TOWN OF PORTOLA VALLEY

MEMORANDUM

SUBJECT: Architectural and Site Development Review of a 1,047 square foot

addition to an existing single-family residence that would exceed 85% of the allowed floor area in the main residence. 166 Corte Madera; Albert

• SHEET: T-0.6

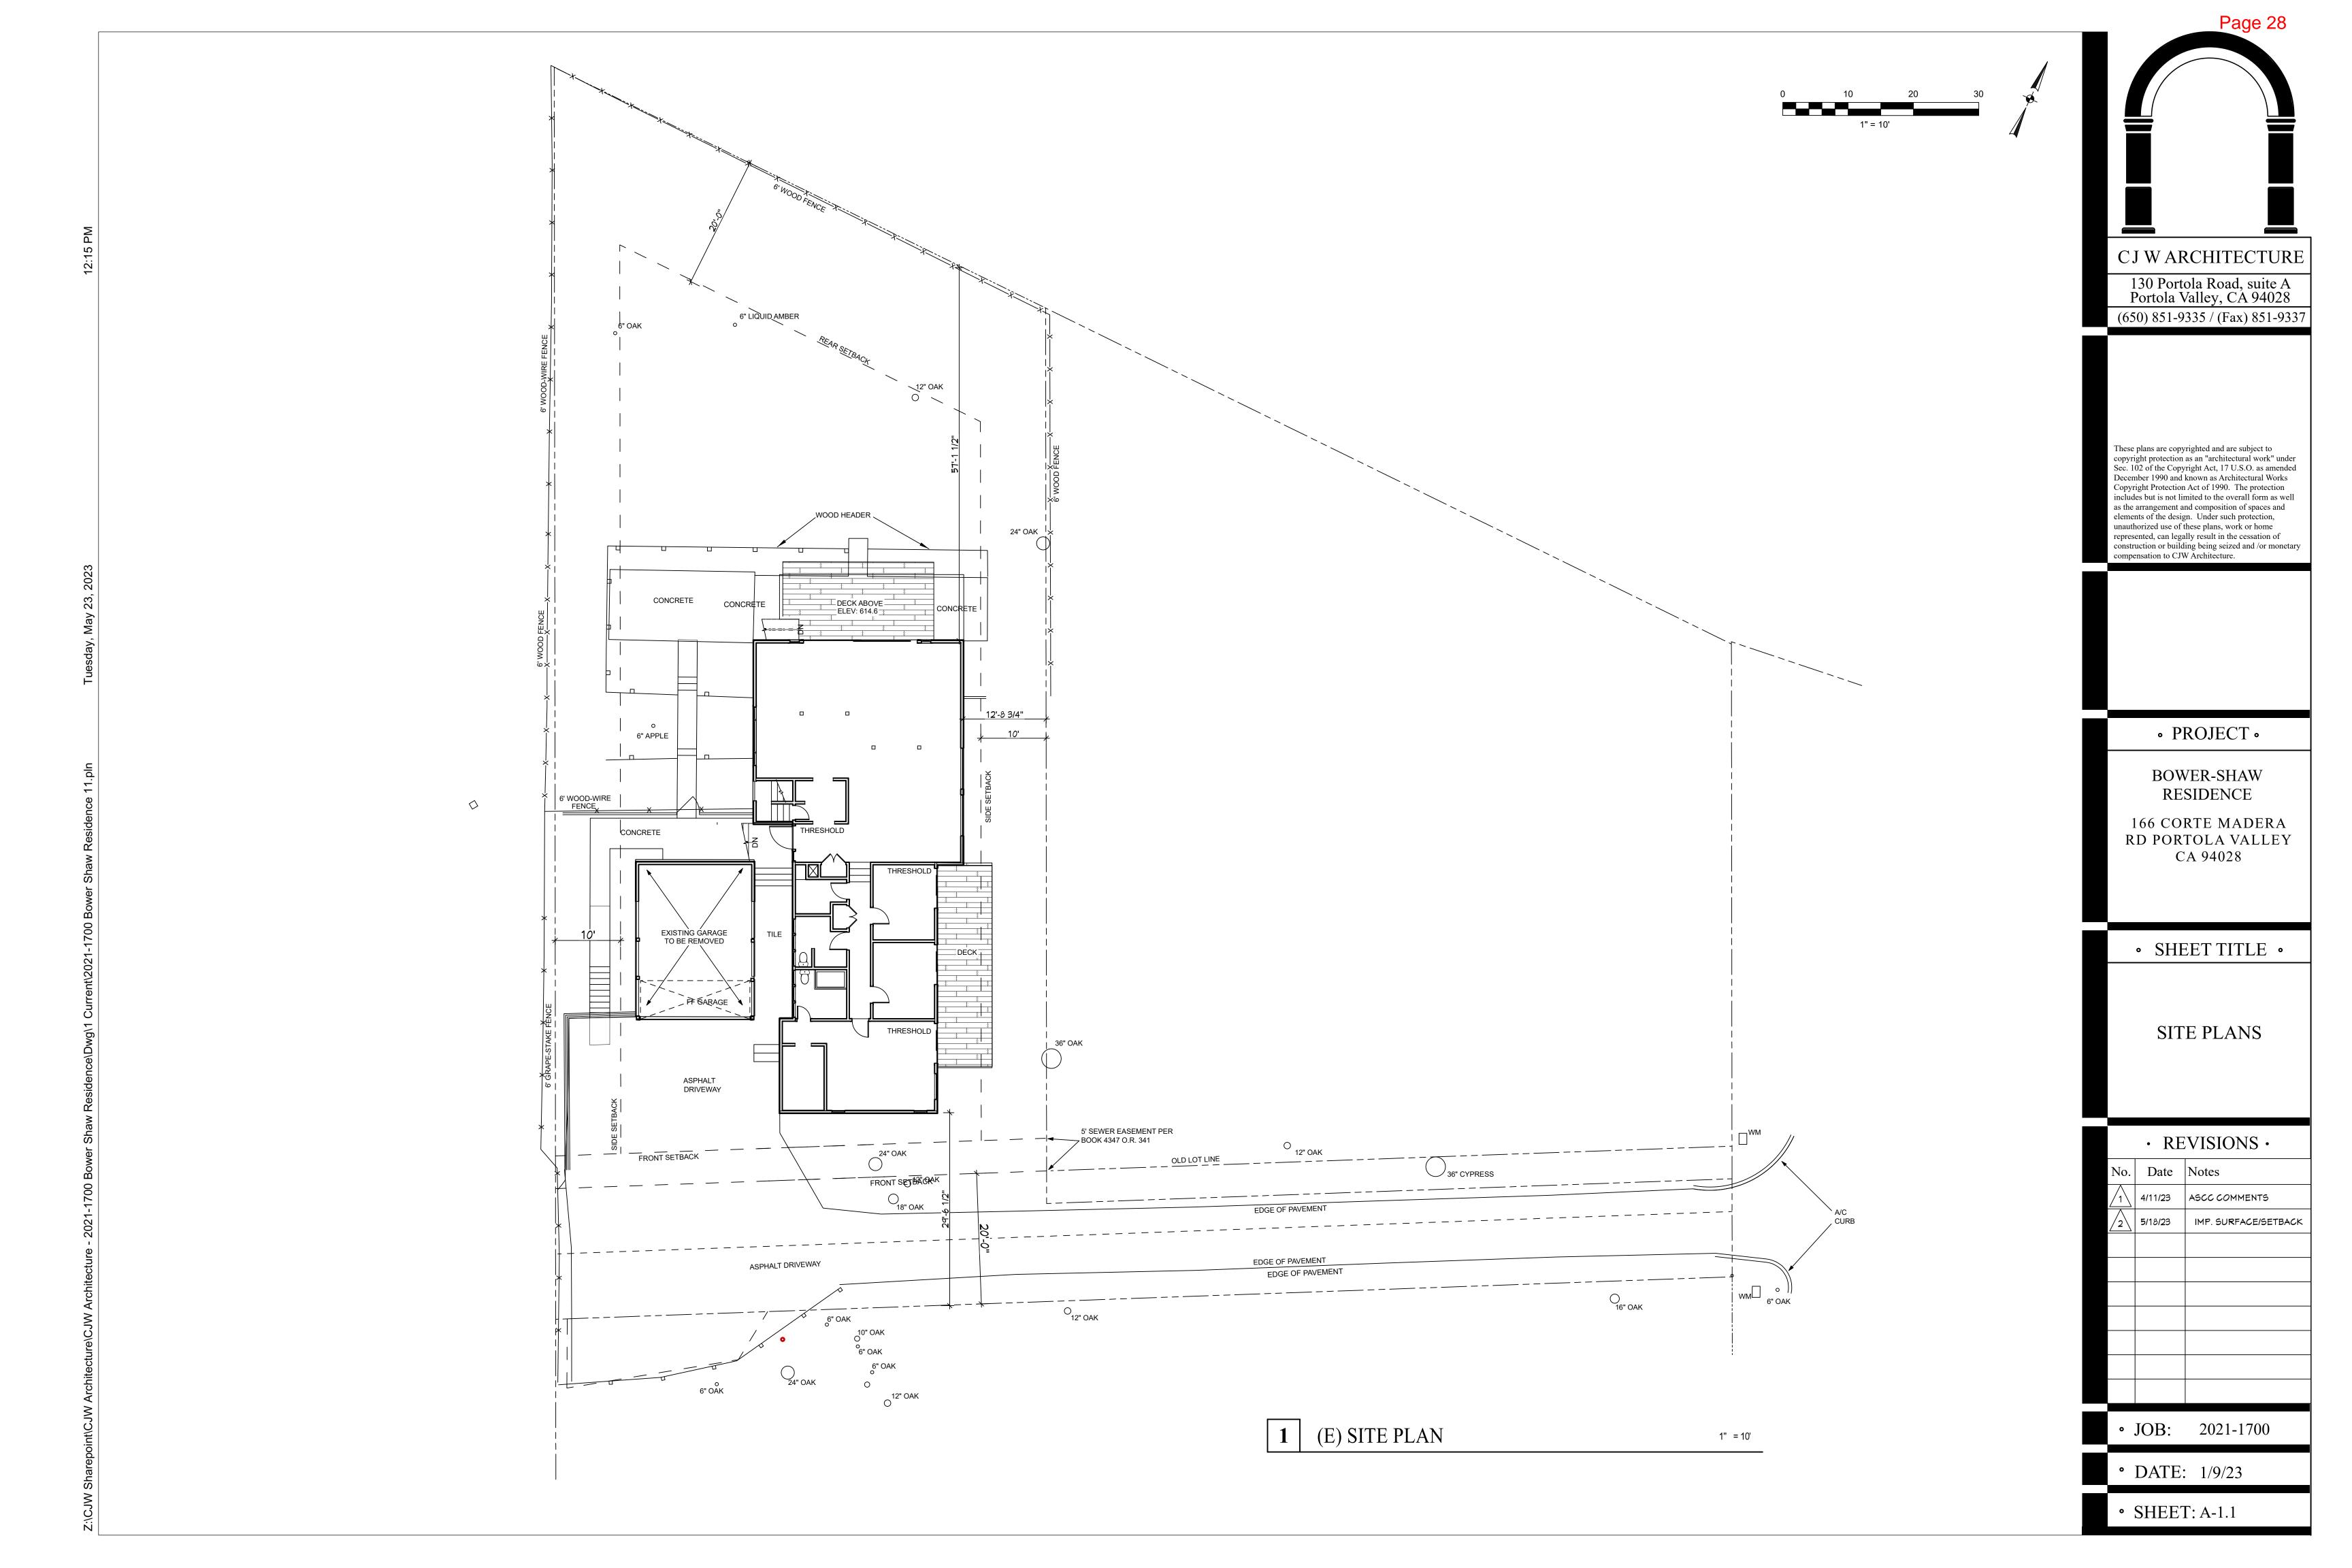
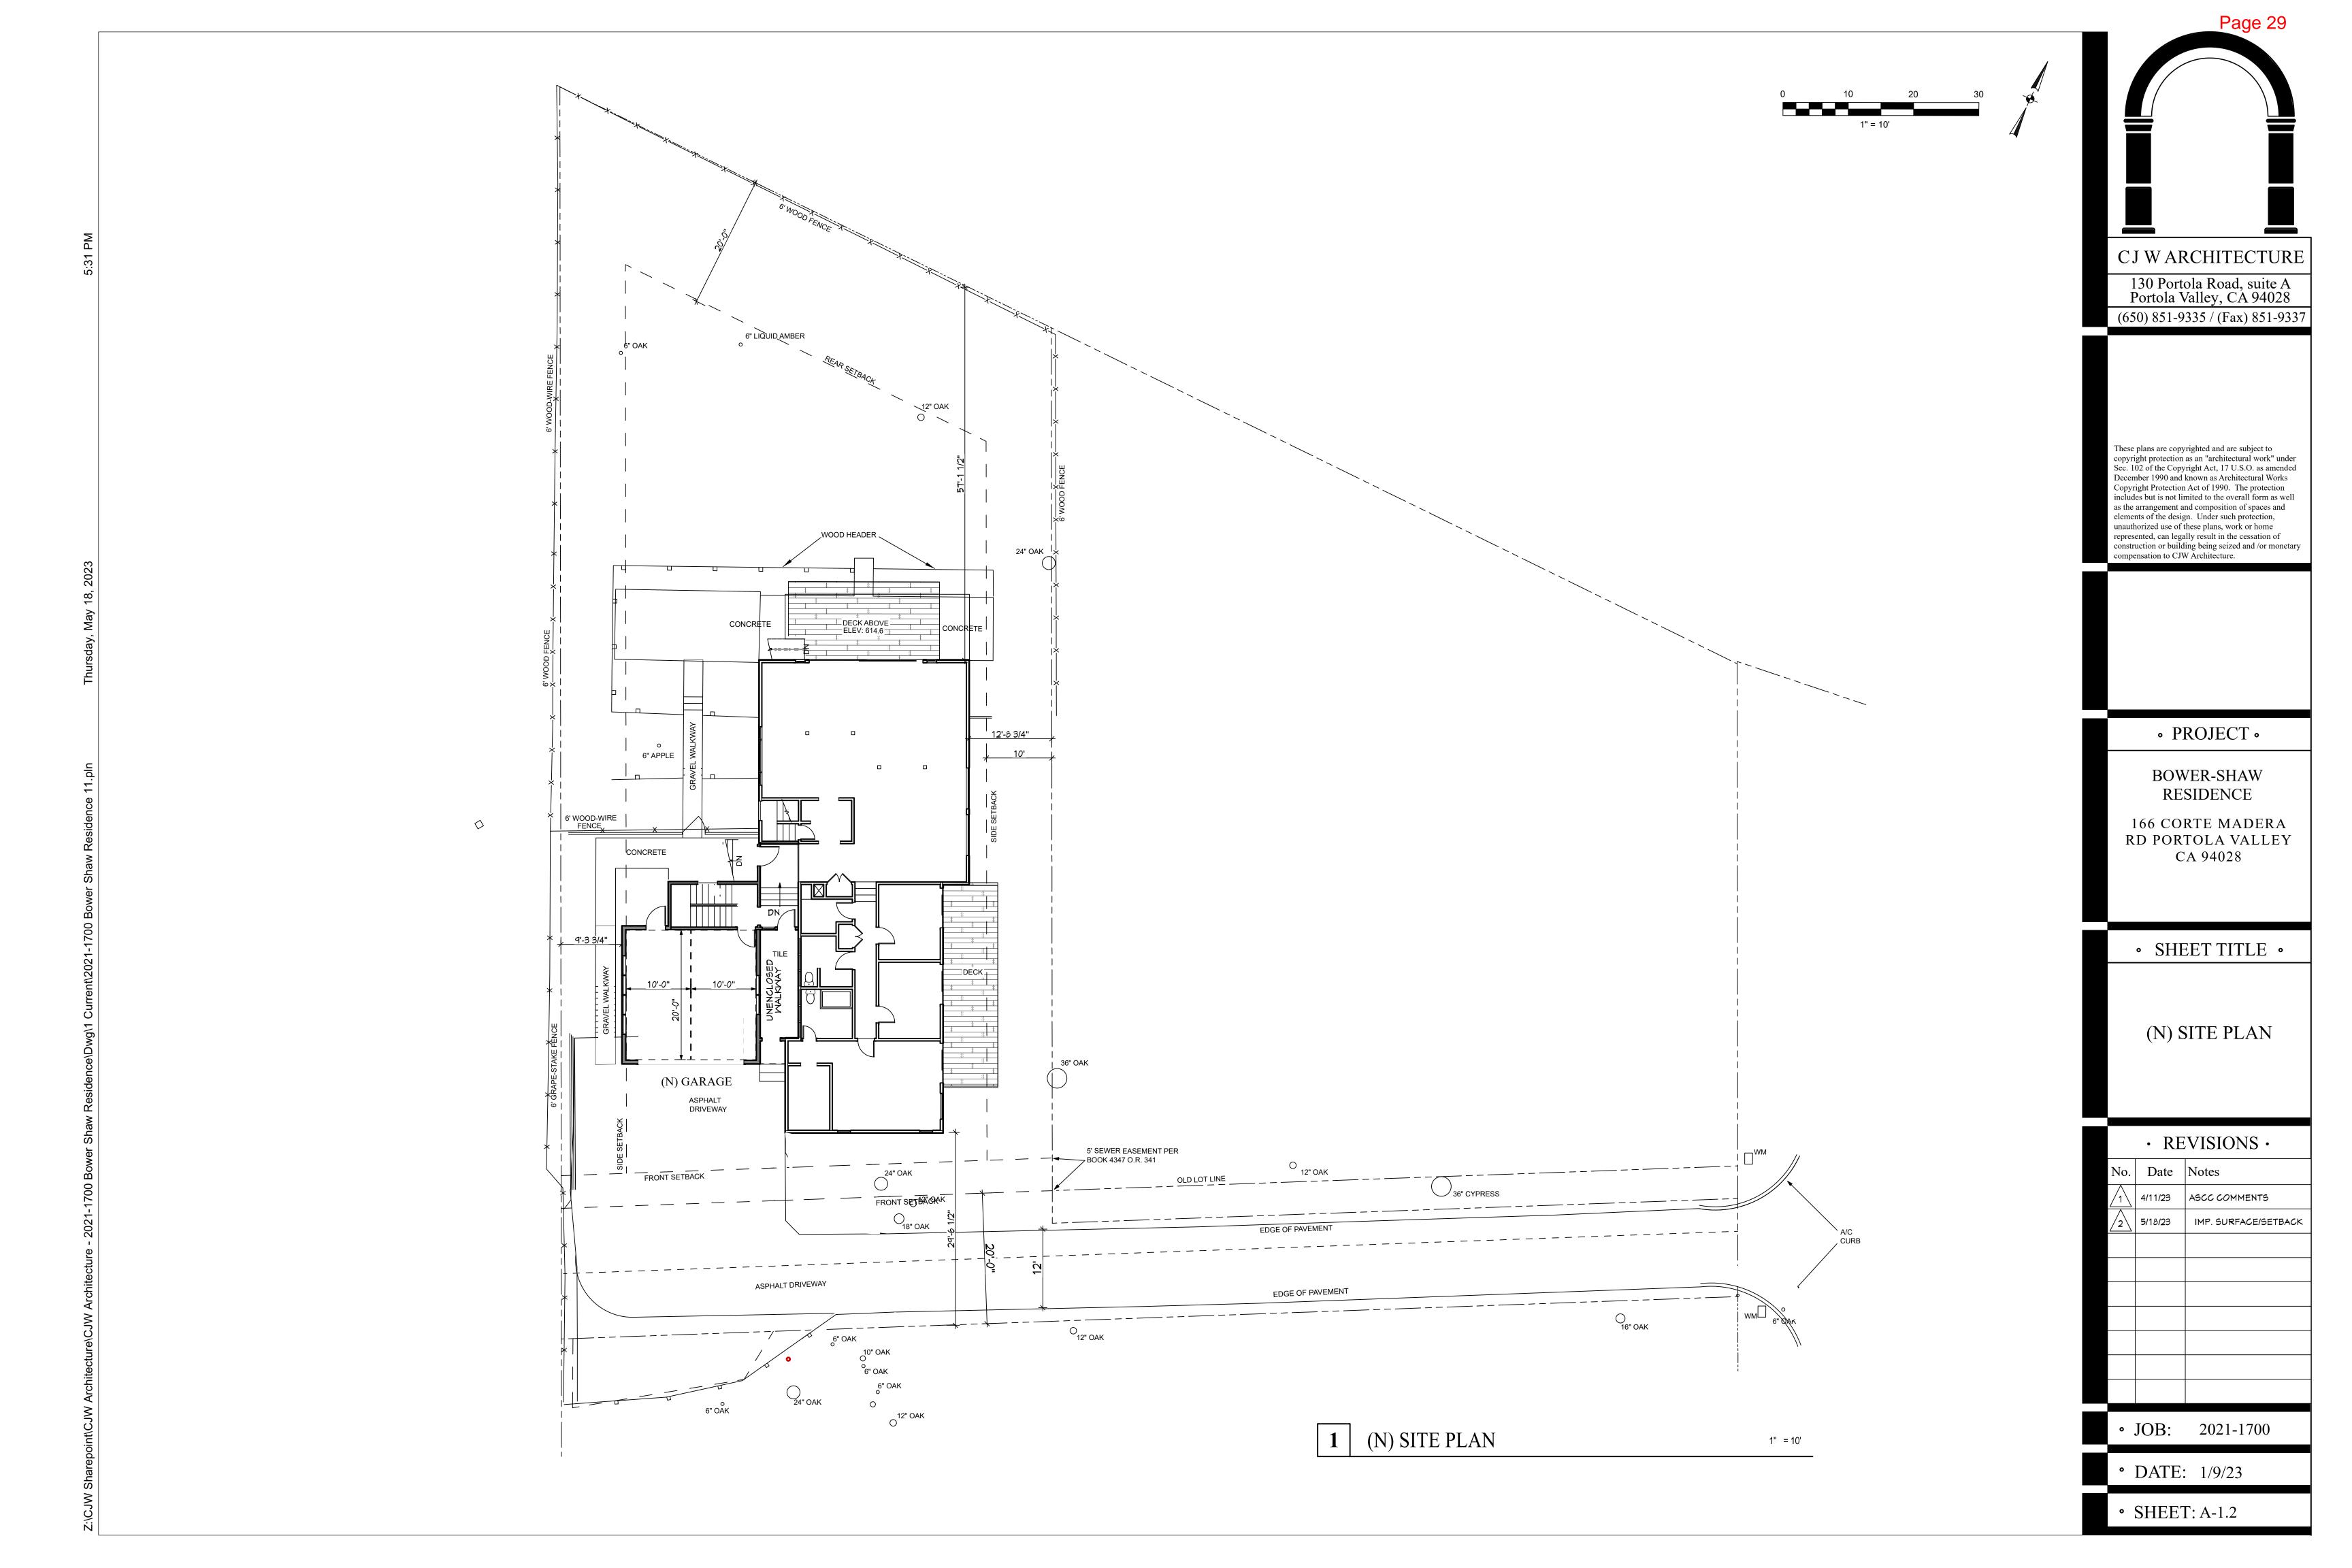
Exterior lighting proposed on the house exterior consists of five (5) new lighting fixtures. Fixtures include two (2) 805 lumen sconces and three (3) 700 lumen sconces. Proposed lighting is dark sky compliant, downlit, shielded, and complies with Town's Outdoor Lighting Ordinance. Lighting for the wall fixtures is included on Sheet A-2.3 and the lighting plan is located on sheet T-0.6 of the project plans (Attachment 6).
